ADDENDUM NO. 1
TO
CITY OF AUBURN, MAINE
2014 MPI PROJECT
December 26, 2013

The following changes have been made to the Bid Documents:

UNDERDRAIN
605(01)

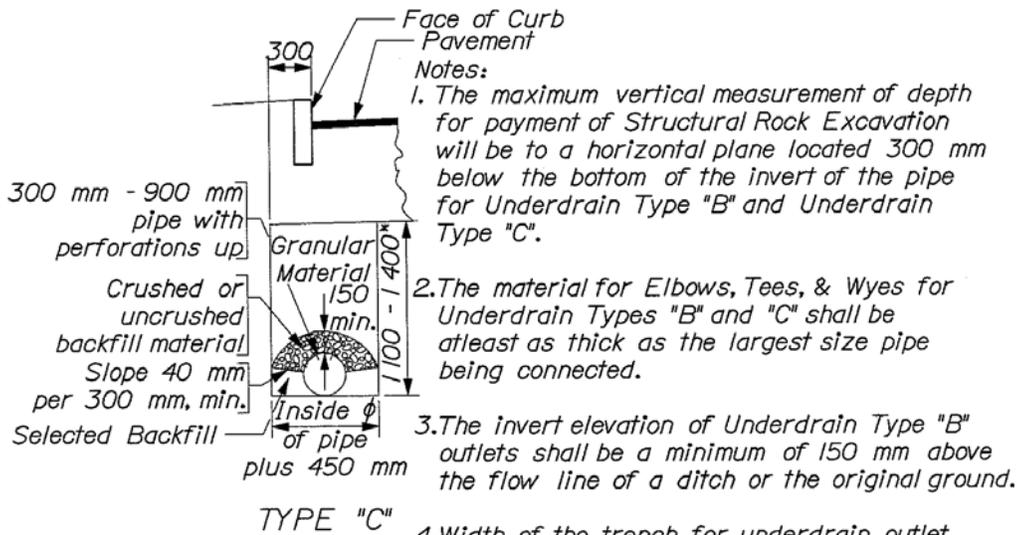
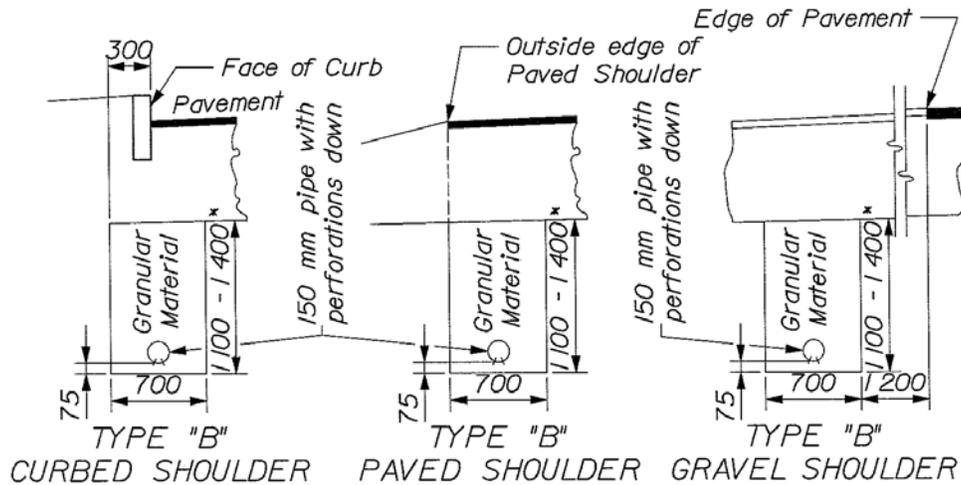
1. The bid opening date has been changed to Thursday, January 9th, 2014 at 2:00pm. Bids will be publicly opened in Room 206, Auburn City Hall, at that date and time.
2. Item 605.11- 12” Underdrain Pipe, Type C, has been added to the bid form which is attached to this addendum. Also note that the quantity for Item 603.15- 12” Culvert HDPE Pipe has changed. A standard detail for Type B & C underdrains is also attached to this addendum.
3. Item 605.09- 6” Underdrain Pipe, Type B shall either have a filter sock or the granular material (underdrain sand) be wrapped with filter fabric.

- Notes:
1. The maximum vertical measurement of depth for payment of Structural Rock Excavation will be to a horizontal plane located 300 mm below the bottom of the invert of the pipe for Underdrain Type "B" and Underdrain Type "C".
 2. The material for Elbows, Tees, & Wyes for Underdrain Types "B" and "C" shall be at least as thick as the largest size pipe being connected.
 3. The invert elevation of Underdrain Type "B" outlets shall be a minimum of 150 mm above the flow line of a ditch or the original ground.
 4. Width of the trench for underdrain outlet will be the same as the underdrain trench.
 5. No allowance for payment will be made for excavating or material excavated beyond the horizontal dimensions shown for Types "B" or "C" Underdrain.
 6. In "Box Sections" the edge of the trench shall be in line with the edge of box section.
